Subject: Waterford 3 SES
Docket No. 50-382
License No. NPF-38
Modification to Primary Access Point

Modification to Primary Access Point

Description of Temporary Alteration
(include affected equipment and function)

WATERFORD S.E.S. UNIT NO. 3 1165 MW INSTALLATION	
	RECONFIGURATION OF PRIMARY ACCESS POINT PER TAR 95-010	
SCALE: NTS	APPROVED 	DATE: 8-1-95
DEPT. DRAFTING		SK-B-C-0157
DR. JAS		
CH. M/S

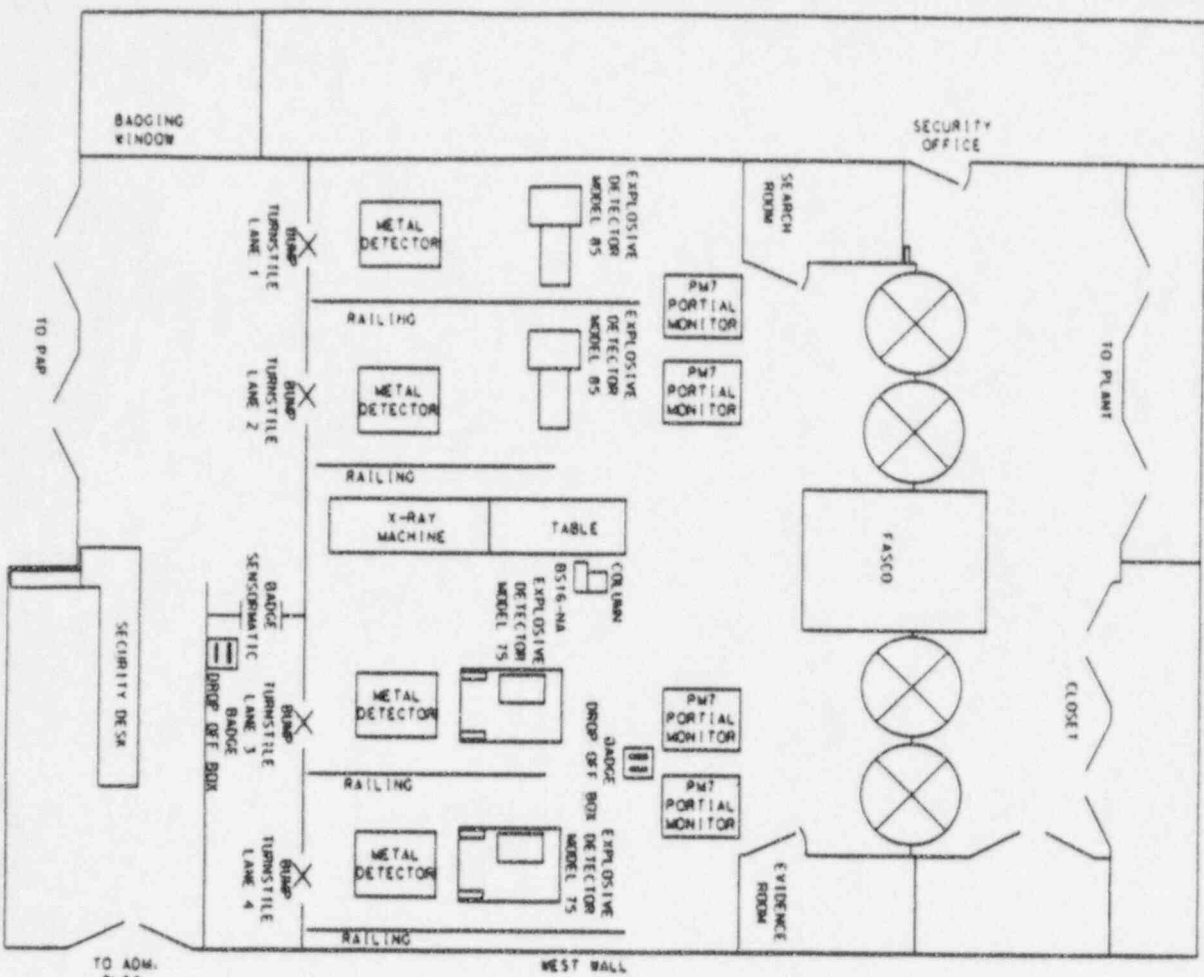
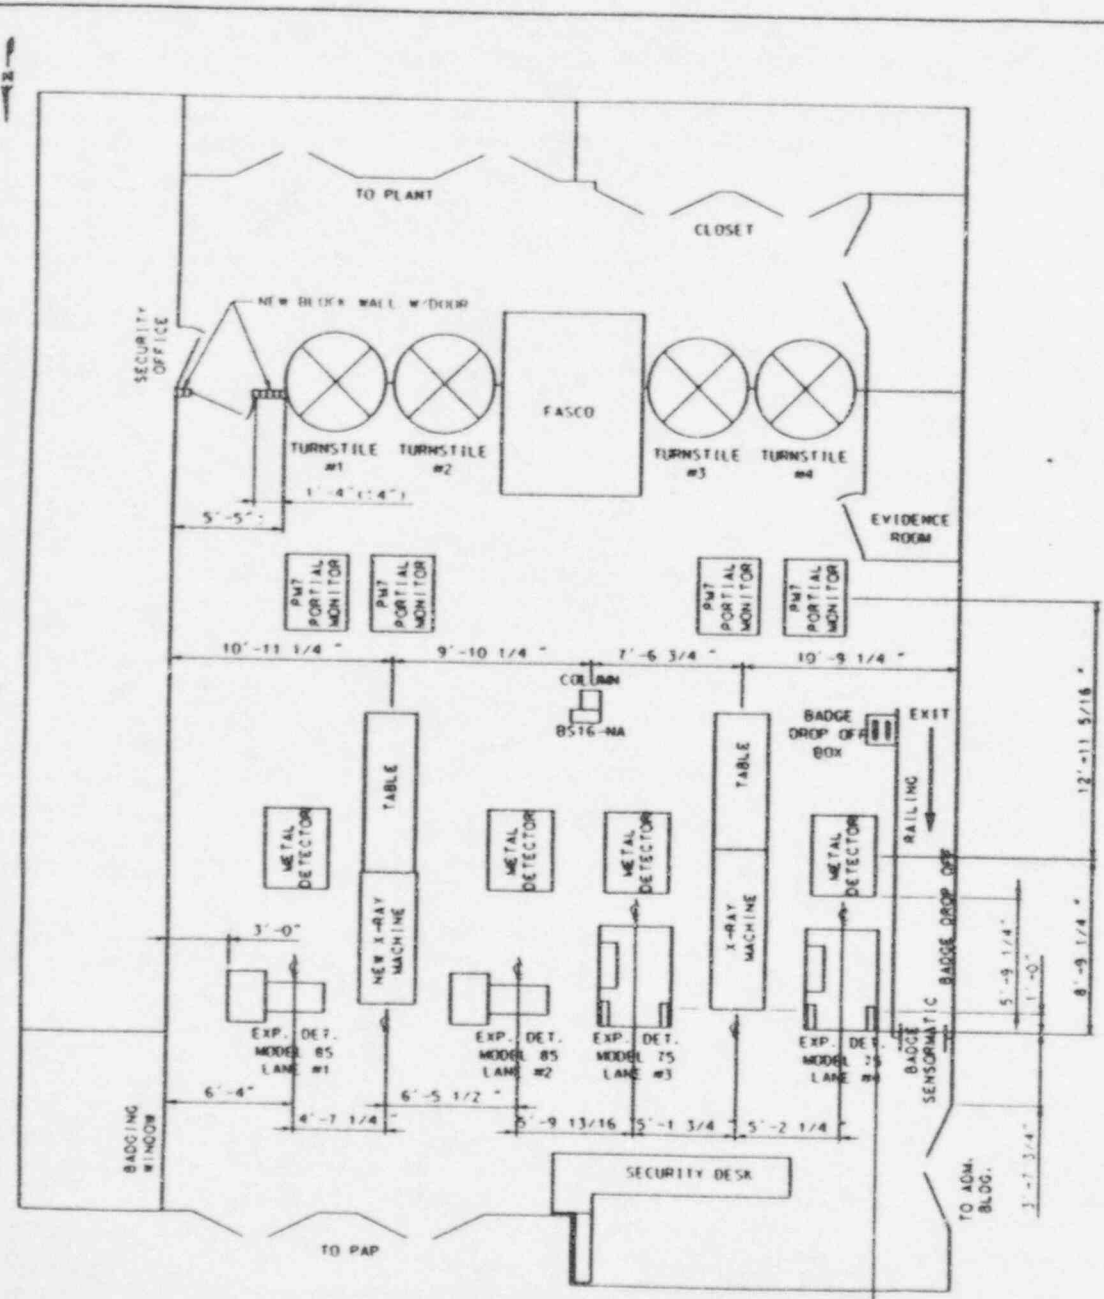
This Temporary Alteration will revise the layout of the PAP (See sketch SK-B-C-0157) to help expedite personnel and package monitoring by accomplishing the following:

- 1) Remove all bump turnstile stands.
- 2) Remove all rails except exit rail.
- 3) Swap metal detectors and explosive detectors.
- 4) Add new Hi-Scan 6040-A X-Ray machine between lanes 1 and 2.
- 5) Relocate existing X-Ray machine and mirror between lanes 3 and 4.
- 6) Relocate Sensormatic equipment to front of exit lane.
- 7) Install new security hollow metal door (DQ12) with lockset in South masonry block wall adjacent to gate turnstile 1.

- 1) ALL DIMENSIONS HAVE A TOLERANCE OF $\pm 1'-0"$ TOLERANCE.
- 2) SECURITY TO RELOCATE THE BADGE DROP OFF BOX.
- 3) REFER TO TAR 95-010 ENGINEERING INSTRUCTIONS FOR INSTALLATION & RELOCATION OF EQUIPMENT.
